## IFB SU-071119 New Pedestrian Walkway Project Addendum #1 \* August 9, 2019

SUNY Purchase wishes to make the following clarification to IFB SU-071119

# Wood Outdoor Bench, Woodtone

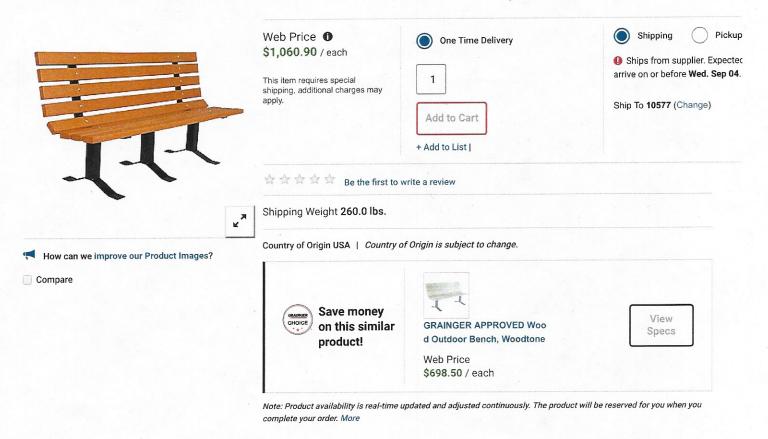
The final specifications for the two (2) required walkway benches are provide for review and reference.
